SUBMITTAL# 6500-2-0 **SPEC** 6500

SHOP DRAWING / SUBMITTAL REVIEW

Customer:
KOCOSON LLC
2075 WALTON CREEK RD
STEAMBOAT SPRINGS, CO
BUILDING 1

Scale : 1/4" = 1'
Date : 10/23/2025
Building Code : IBC 2021
Drawn By : Henry Wolfe
Job Number : Q250433 AKA 4819602

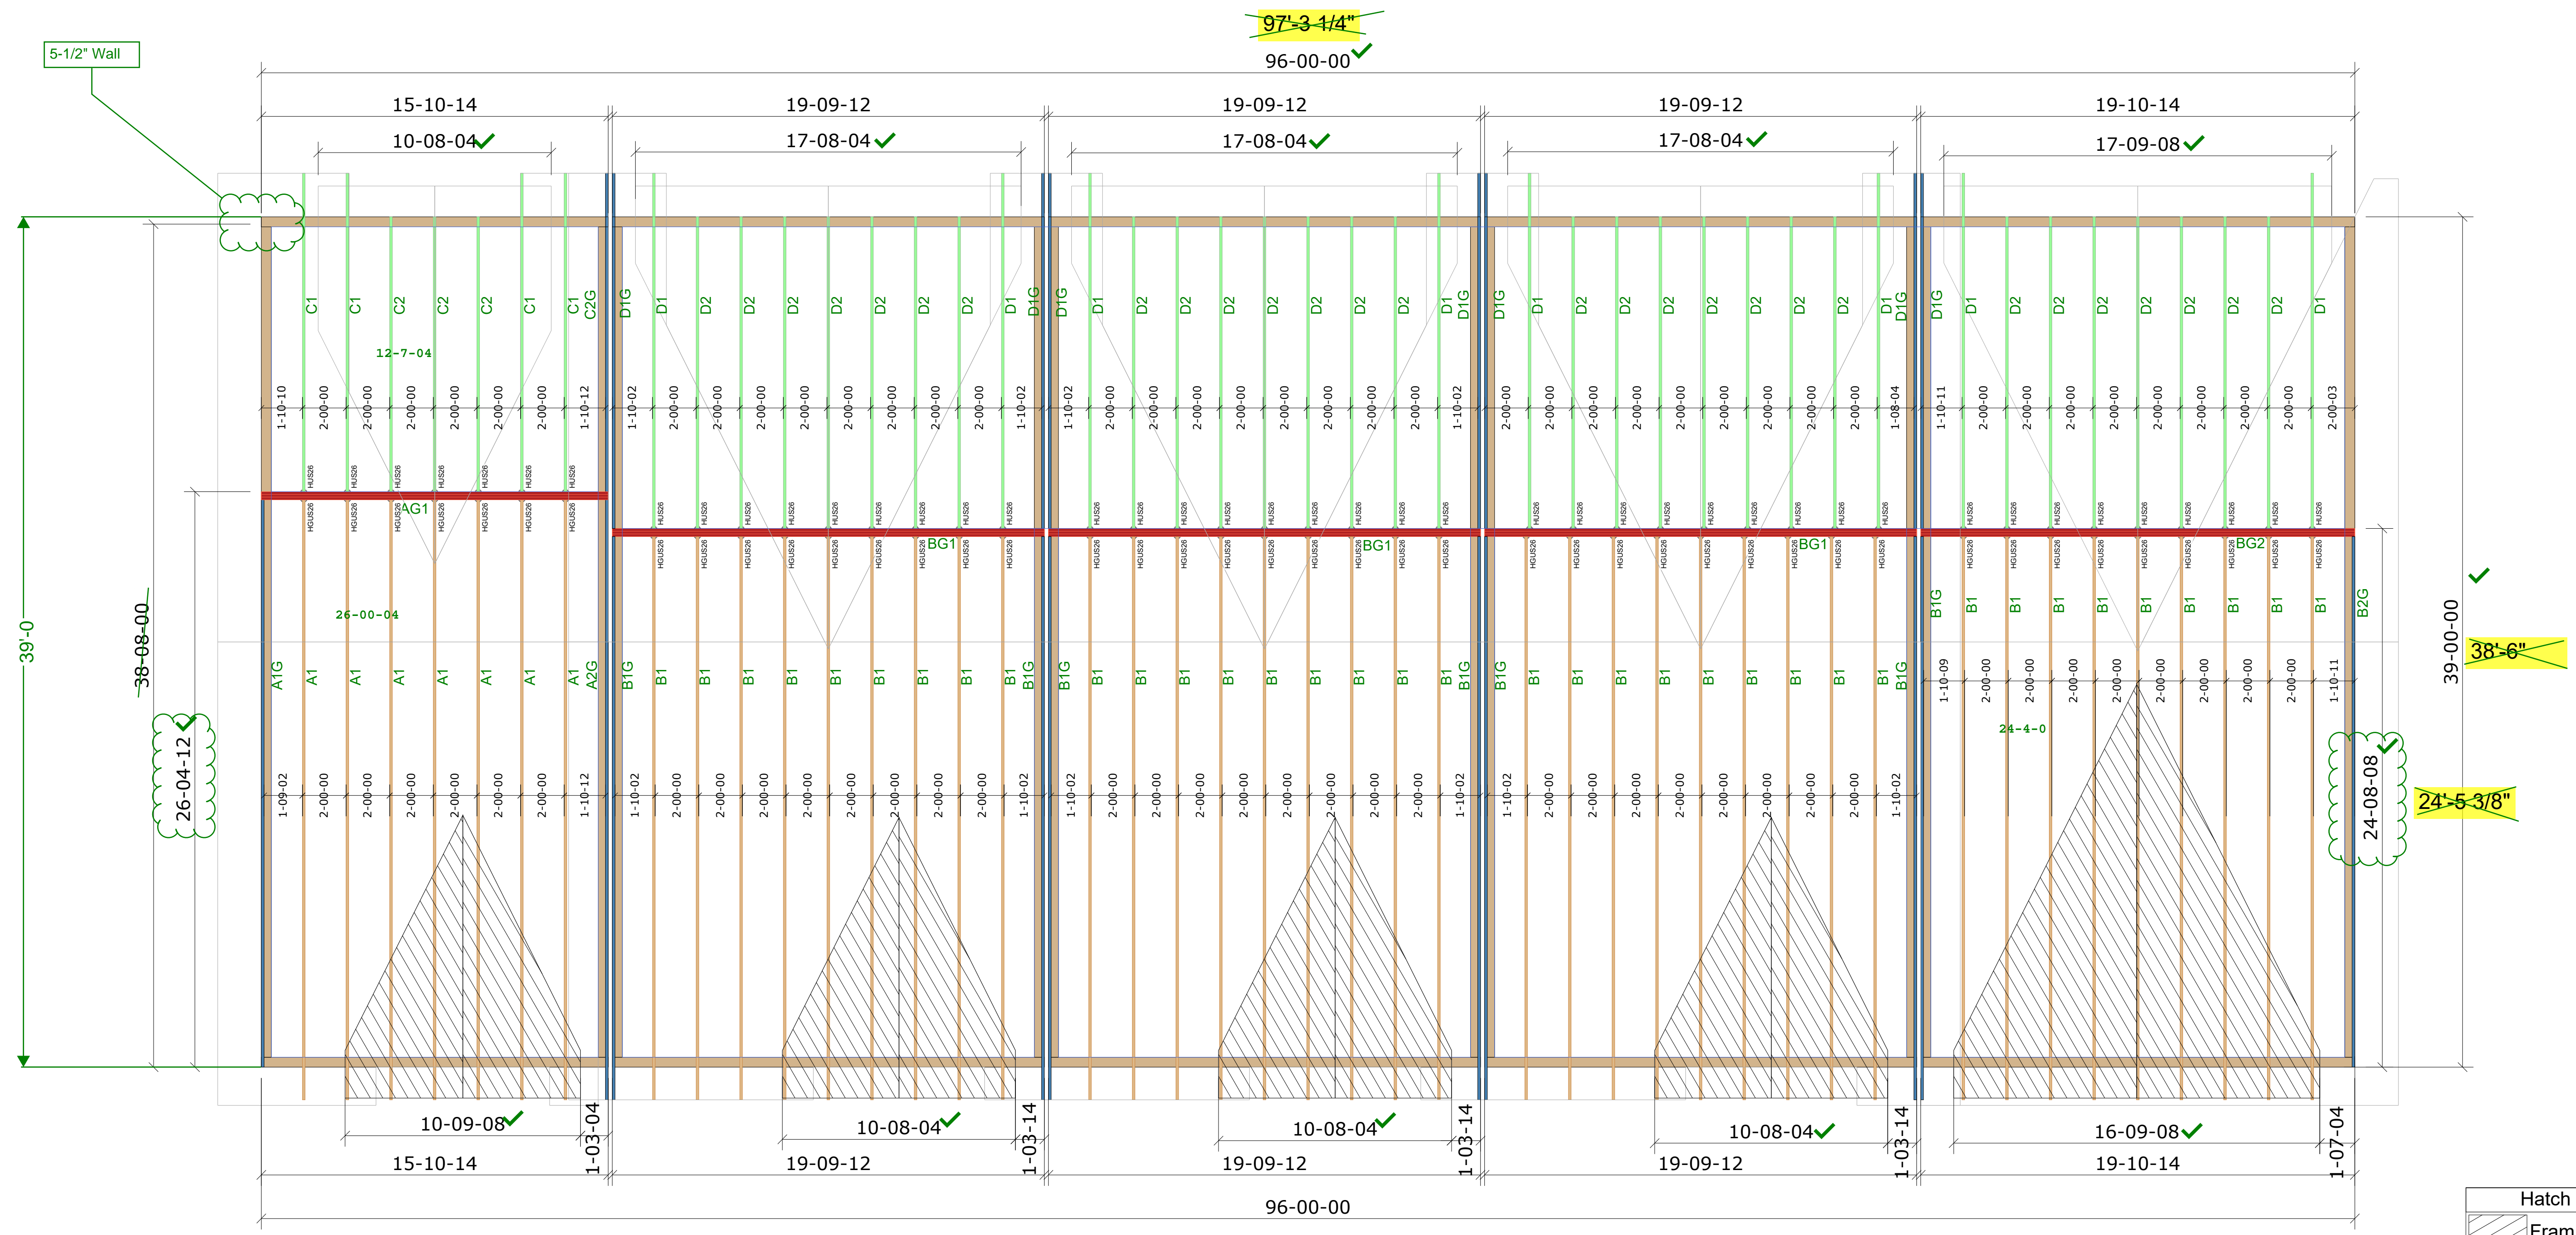
~~SEE DIMENSION
CORRECTIONS IN YELLOW
HIGHLIGHT. COORDINATE AS
REQ'D.~~

DIMESIONS ON THE SHOP DRAWINGS ARE PER FIELD VERFIED MEASUREMENTS, BASED ON STRUCTURAL DRAWINGS AND THE FOUNDATION INSTALLED. TRUSS TAILS TO BE CHANGED AS NOTED BY ARCH (1/22/26).

STRUCTURAL ENGINEER
APPROVED ALL LOADING,
REACTIONS, DEFLECTIONS,
LAYOUT, SHAPES VIA EMAIL.

Job Q250433	Truss C2	Truss Type Jack-Closed	Qty 3	Ply 1	KOCON LLC Job Reference (optional)
----------------	-------------	---------------------------	----------	----------	---------------------------------------

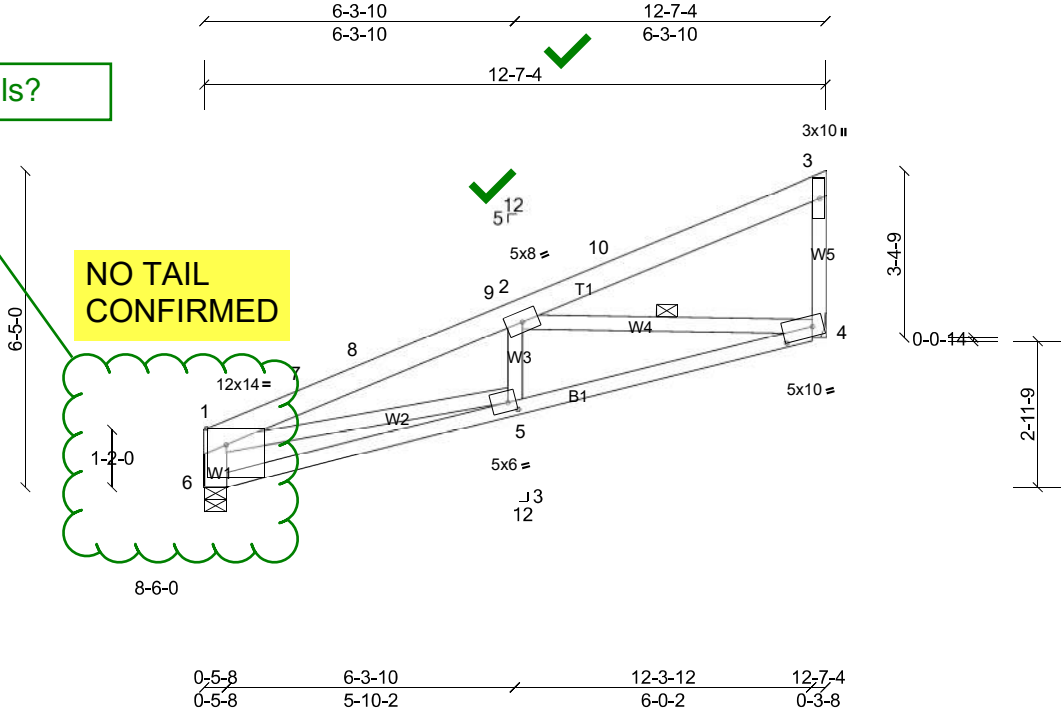
Verify, truss tails?
